REMEDIAL ACTION PLAN ADDENDUM FOR ELECTRIC POWER PLANT BUILDING 103 NAS
KEY WEST FL
3/1/1995
ABB ENVIRONMENTAL SERVICES INC

REMEDIAL ACTION PLAN ADDENDUM

**ELECTRIC POWER PLANT, BUILDING 103
NAVAL AIR STATION KEY WEST
KEY WEST, FLORIDA**

This RAP Addendum includes responses to FDEP comments dated January 26, 1995. Major comments posed by FDEP focus on the following issues:

WATERSTOP DETAIL
HALF SCALE

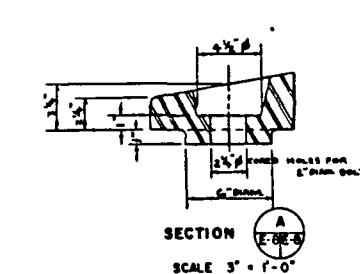
4	page 3-6/ para ii and iii	<p>Tidal induced ground water fluctuations reduces the credibility of the "theory" that the bulkhead is hydraulically impermeable and is an effective barrier to contaminant migration. The Navy should report the magnitude and upland extent of the tidal influence and assess the extent of the hydraulic connection between ground water and surface water in a more quantitative manner. If enough data exist, a flow net analysis may be one of various methods adequate to accomplish it. Any persuasively presented analysis based on good scientific principles will be acceptable.</p> <p>Page 2-1, Section 2.2 reports that "There are existing underground utilities throughout the pier area..." Damaged and inadequately maintained storm drains through similar bulkheads at other Naval bases (e.g., NS Mayport, Alpha Delta pier) have acted as direct conduits to surface water for contaminated ground water. The Navy should adequately verify that they have considered and eliminated this potential release mechanism at Site 103, as well.</p>	Yes

The bulkhead is encapsulated within the top 10 feet with concrete measuring at least 8 inches in thickness on the outer face. The base of the encapsulation is 3 feet below mean sea level (msl) as shown in Detail E-4. Rubber water stops have also been included in the concrete joints as shown in Detail E-2. Together, these precautions will effectively prevent any shallow groundwater contaminant transport through the bulkhead.

FIGURE 3-3
SOIL CONTAMINATION DISTRIBUTION,
0 TO 1 FOOT BELOW LAND SURFACE

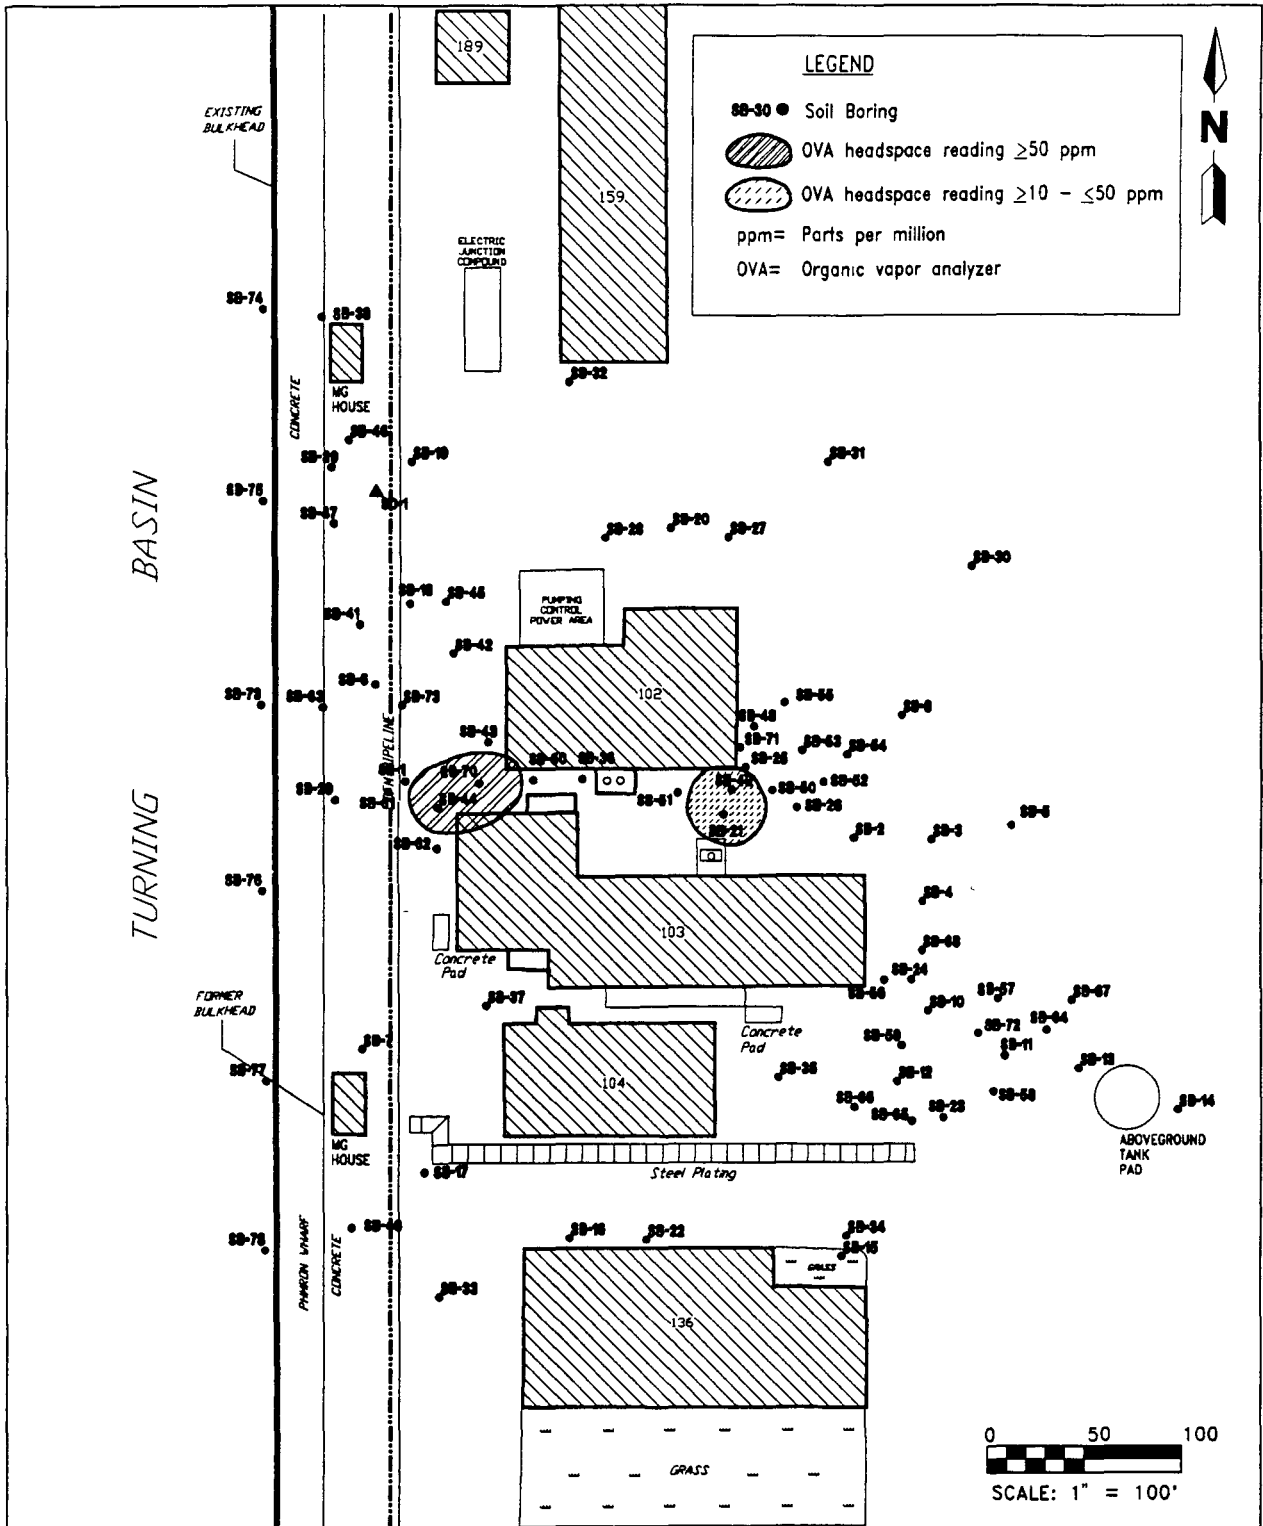
2	page 3-1/ para iii	<p>"Exposure pathways through the soil media are limited; the latter two areas are not considered to contain contaminants of concern." The meaning of this statement is unclear. What exposure pathways? Are there no contaminants of concern because there are no exposure pathways or are there no exposure pathways because there are no contaminants of concern? Since by definition, the three areas shown in Figure 3-2 contain excessively contaminated soils as defined in FAC 62-770, the former condition must apply. Please request the Navy to make more explicit their rationale for this statement including their assumed exposure scenarios. (Answer to comment 1 may help resolve my confusion on this issue.)</p>	Yes
3	Figures 3-3	<p>I am not sure what figure 3-3 is trying to convey. The legend indicates that the shaded area to the west is ≤ 50 ppm. Is this a typo or does it mean that the unshaded areas are greater than 50 ppm (i.e. > 50 ppm)?</p>	Yes

Figure 3-3 legend should show two areas of contamination with contamination levels ≥ 50 ppm and ≥ 10 ppm & ≤ 50 ppm. A corrected figure is shown in Attachment 4.
